We are writing this letter to express our desire to vary two aspects of a proposed accessory building on our property located at 1578 Strathcona Heights in Shawnigan Lake.

ISSUED FOR BOARD OF VARIANCE

PROJECT: NEW DETACHED SUITE + GARAGE

Notes from City:

ELEVATIONS AND CROSS SECTION
A-202

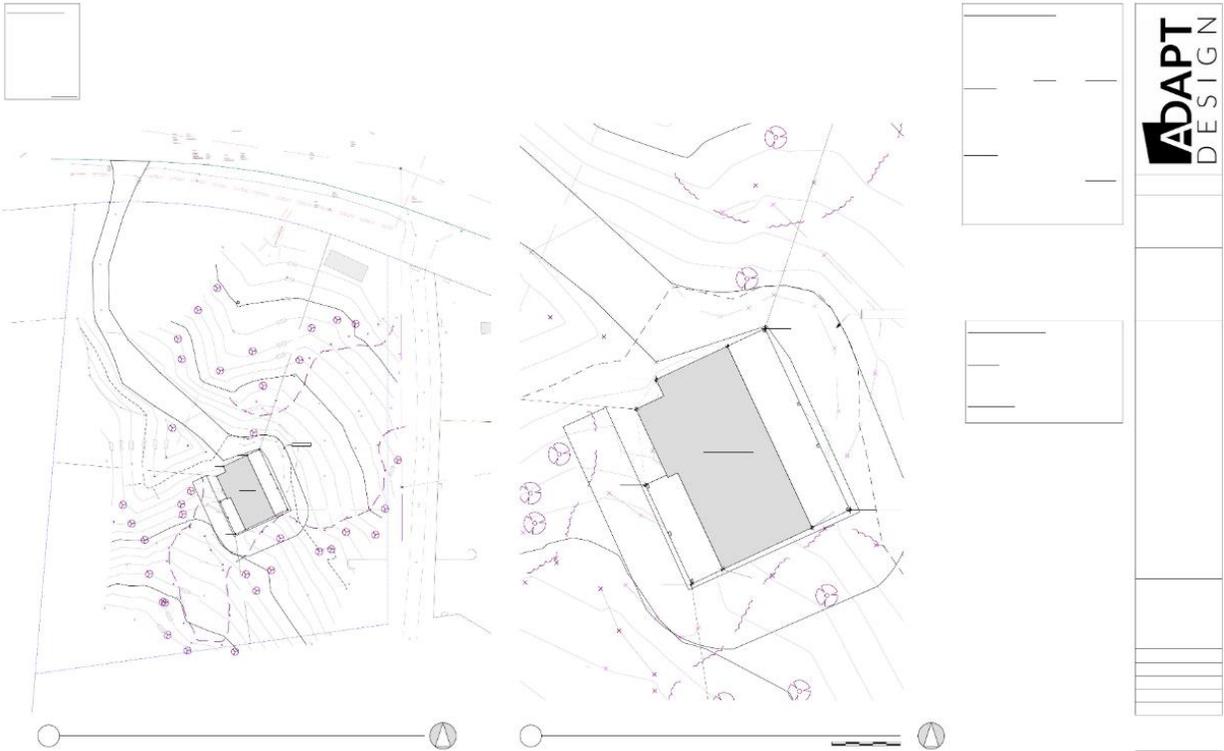
1) Regarding the height variance

a. The additional glazed openings may actually lead to negative overheating rather than positive solar gain when applying step code metrics.

b. Regarding overheating; dwellings built through Building Permits issued on or after March 8, 2024 will require mandatory Air Conditioning – which may cause for increased electrical demand – not less.

c. The owners have stated in their rationale letter that this is a 6 inch variance; however, this is a 2.5m (8.2ft / 98 inch) variance request.

2. Note from Designer: as a former energy advisor, I don't see this being as an issue. Energy modelling takes into account various considerations and trade offs can be made. We've designed hundreds of homes with step code and have never had to make window changes so I would ask that this be requested after your variance is approved.

We plan on having air conditioning, a heat pump will be installed

Apology for the error

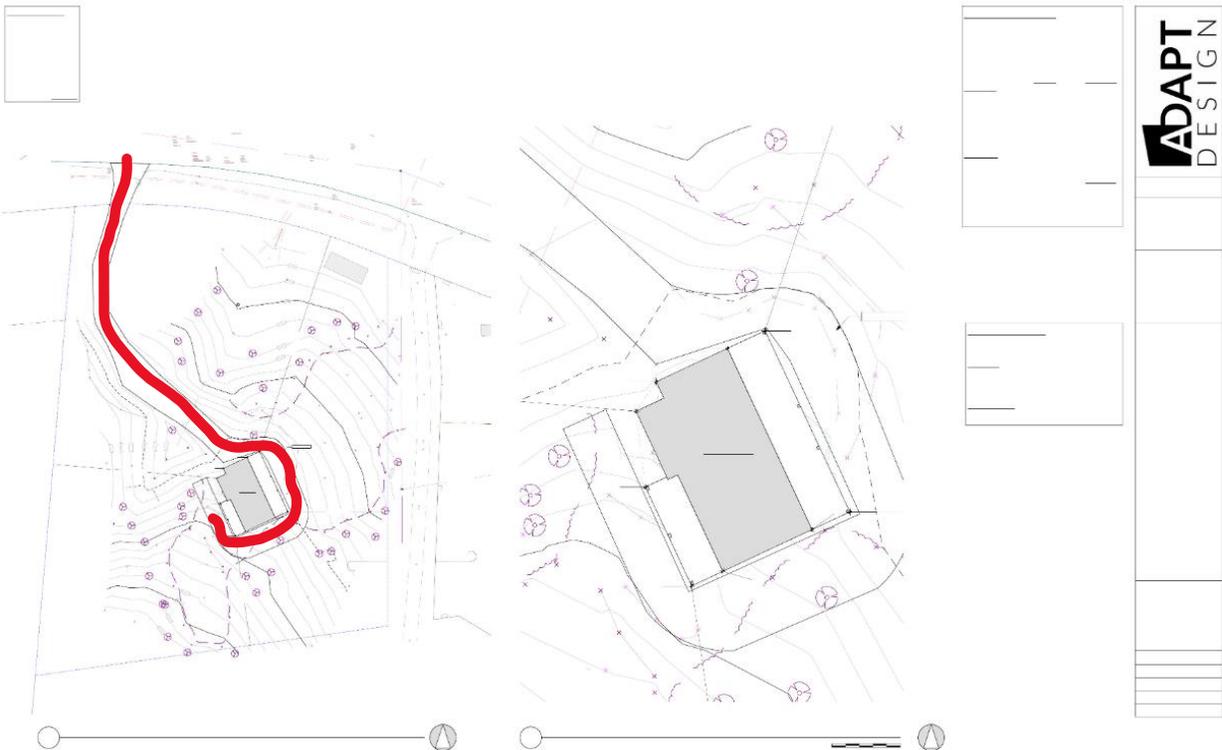
- c. We understand that the owners have advised that there will not be an interior connection between the garage below and the suite above. The drawings have indicated that the garage below will be used for personal storage as well as a home-based business; however, some of the amenities for the residence (e.g. washer/drier) are located in the garage. In order to properly delineate these “tenancies” or floor areas; a fire and sound separation will be required.

- Show the proposed driveway, parking, areas, and pedestrian access to/from the suite (including the location and height of any retaining walls associated with the access)
- Remove the washer/drier from the garage and identify where it will be relocated to within the main floor area.
- “close off” the mechanical room (screen shot below)

4. The garage is separated with a 1 hour fire rated wall including the mechanical area. The reason the washer and dryer is in the garage is because they will have a caregiver providing services like meal prepping, cleaning and laundry for them.

The driveway was already shown on the site plan but I've made it more clear
